Oakton College District 535

Invitation to Bid # 0925-24-03 -Addendum #1
Issue Date: September 25, 2024

Oakton College Des Plaines Adjacencies Renovations - Phase 1

2.) Provide the updated drawing and Project Manual, including responses to the questions submitted by vendors.

3 ADRC & TESTING CENTER DEMOLITION RCP
1/8" = 1'-0"

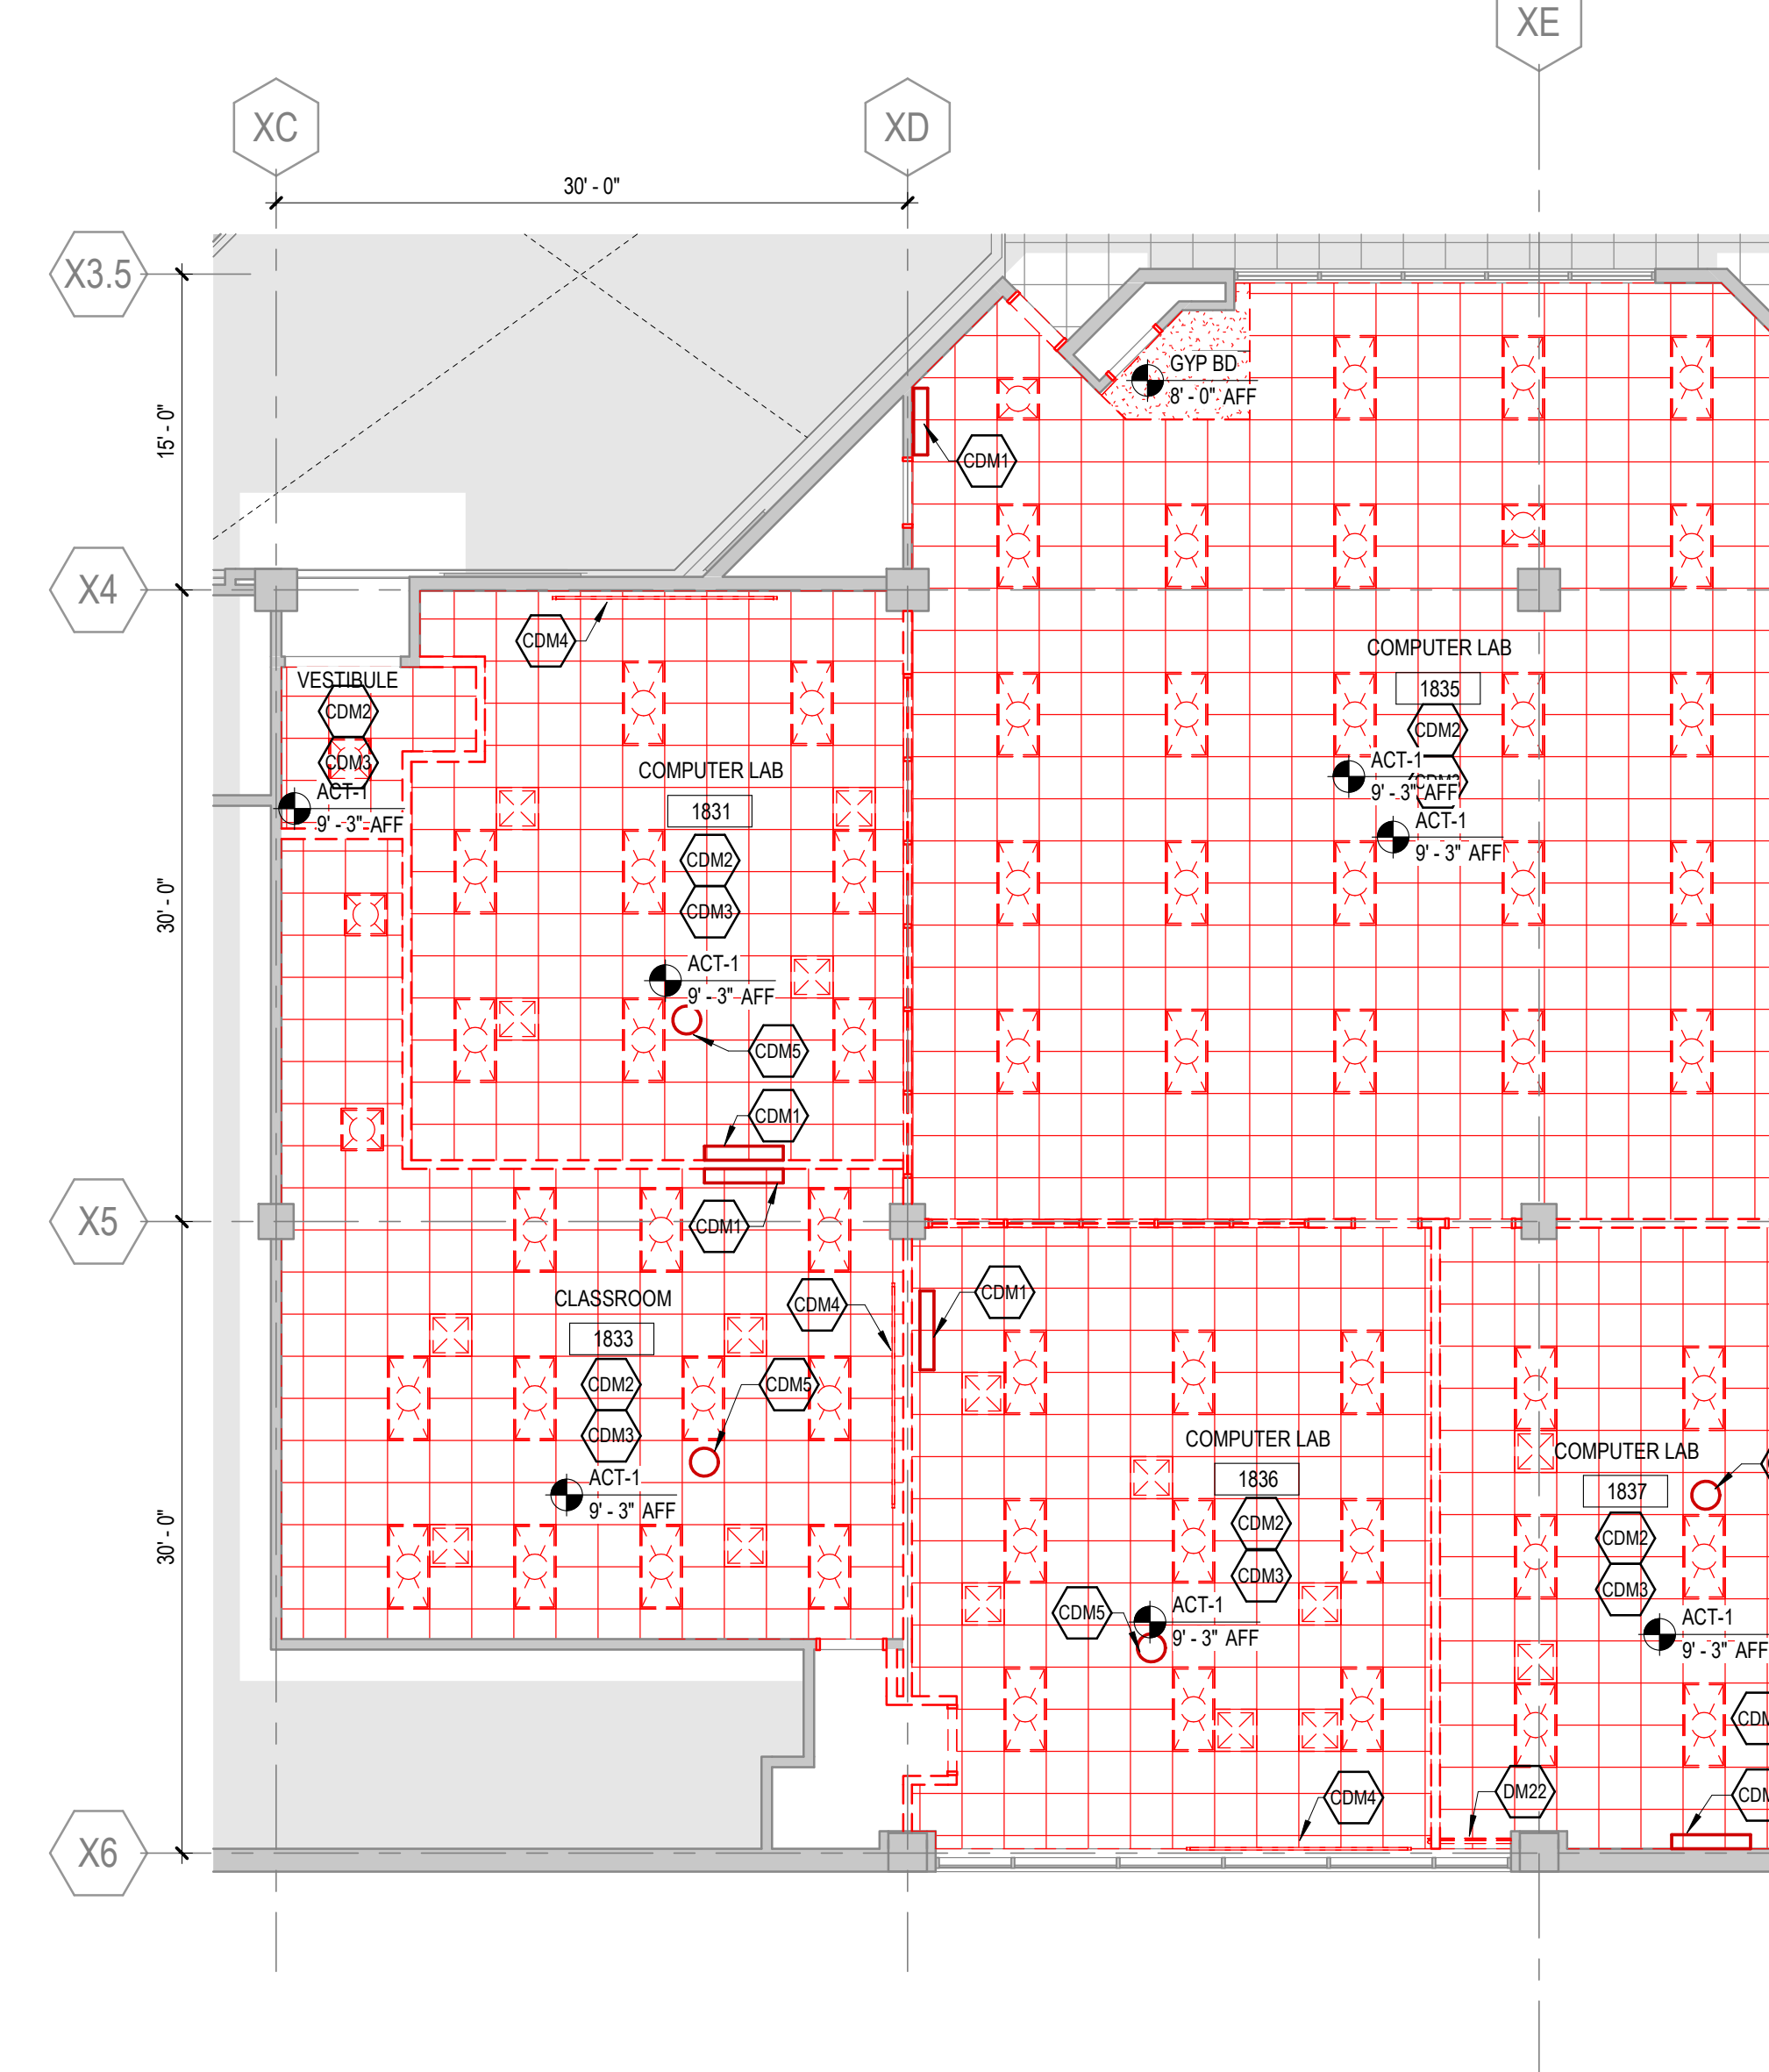
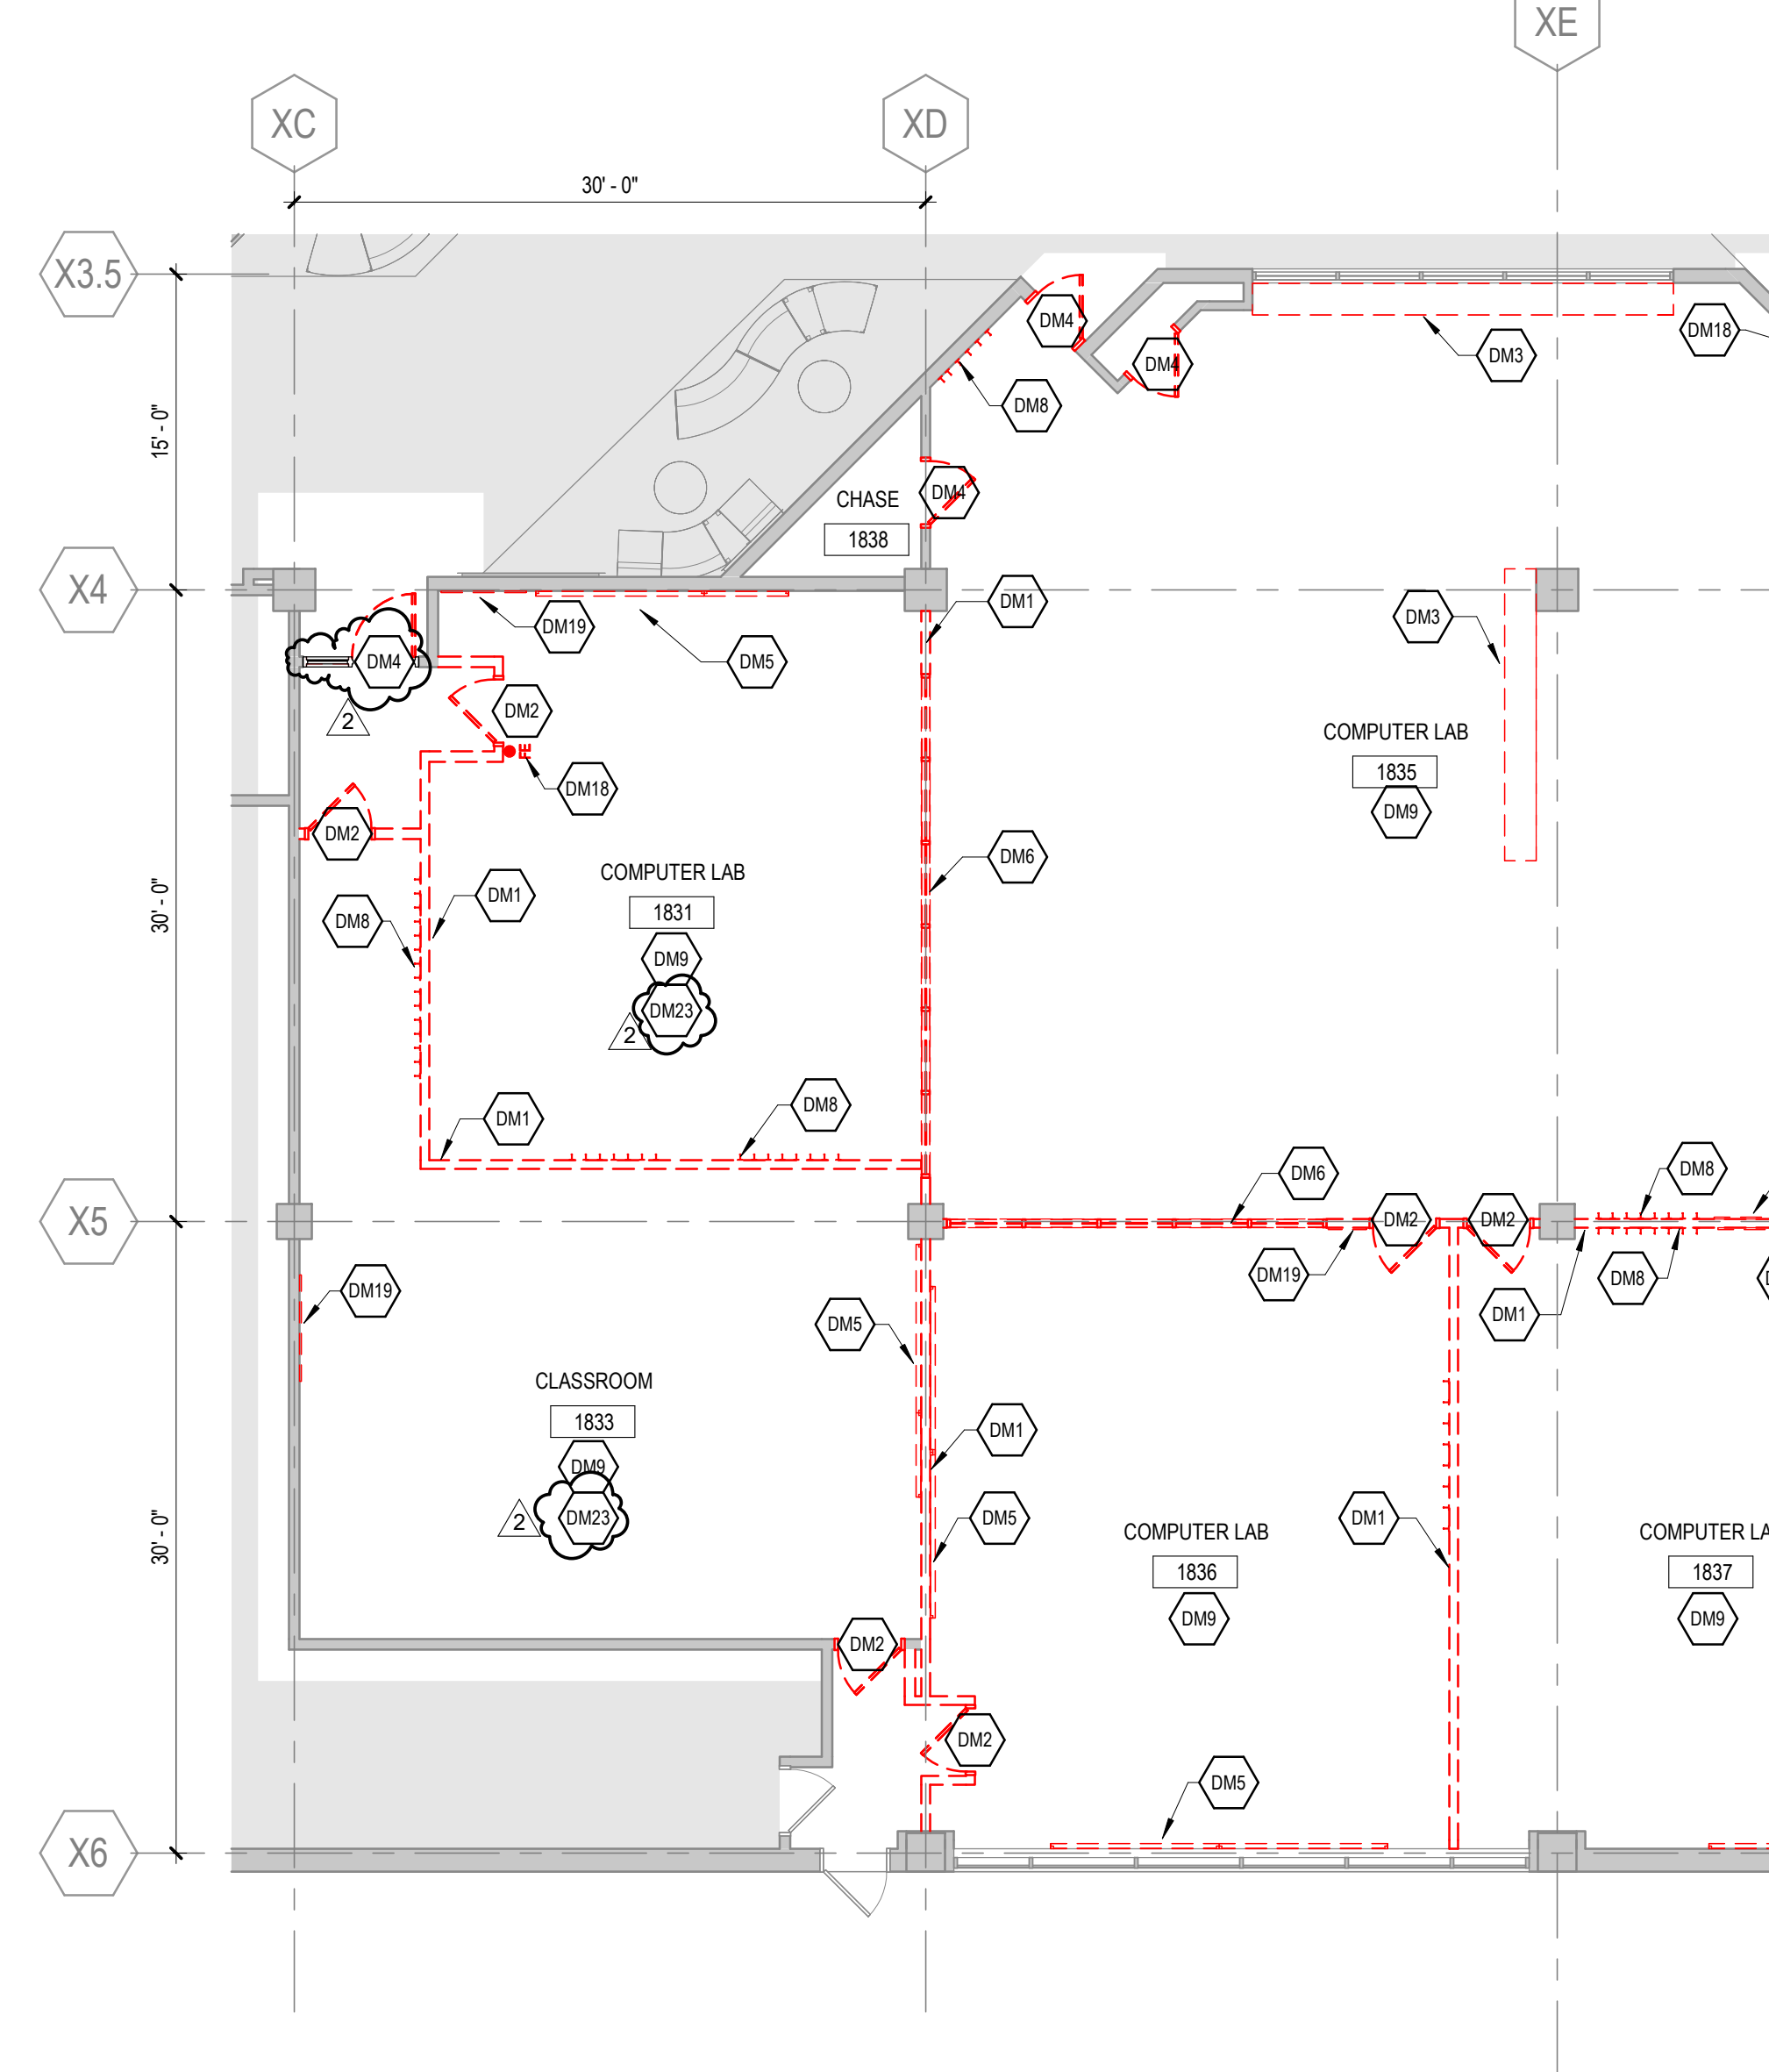
1. General:
 - a. G00-00 Cover: Sheet Index Updated
2. Architectural:
 - a. Sheet .8 A04-01 Demolition Plans
 - 1) Added new RCP demolition keynote regarding window treatments

- 2) Added new demolition keynotes regarding wall protection
 - 3) Added new demolition keynote regarding wall demolition
 - 4) Revised DM4 at Computer Lab entrance

- 5) Revised floor demolition keynotes
 - b. Sheet .8 A11-01 Floor Plans & Floor Details
 - 1) Added wall furring at window
 - c. Sheet .8 A12-01 Reflected Ceiling Plans

15. On drawing A04-01 in room 2262 there is some sort of epoxy paint for flooring in lieu of carpet. Please clarify if that is to be removed.

16. Are any of the window shades to be removed on the existing windows? There are not called to be removed and drawing A12-01 is calling for new window treatments. Please clarify.

21. On drawing A04-01 in room 1833 there is an existing wall protection chair rail, but it is not called to be removed. Is it to be removed and what wall patching is required after it is removed? Please clarify.

A: See revised sheet A04-01.

A: See revised demolition RCP on A04-01.

A: See revised sheet 8.A04-01 Demolition Plans.
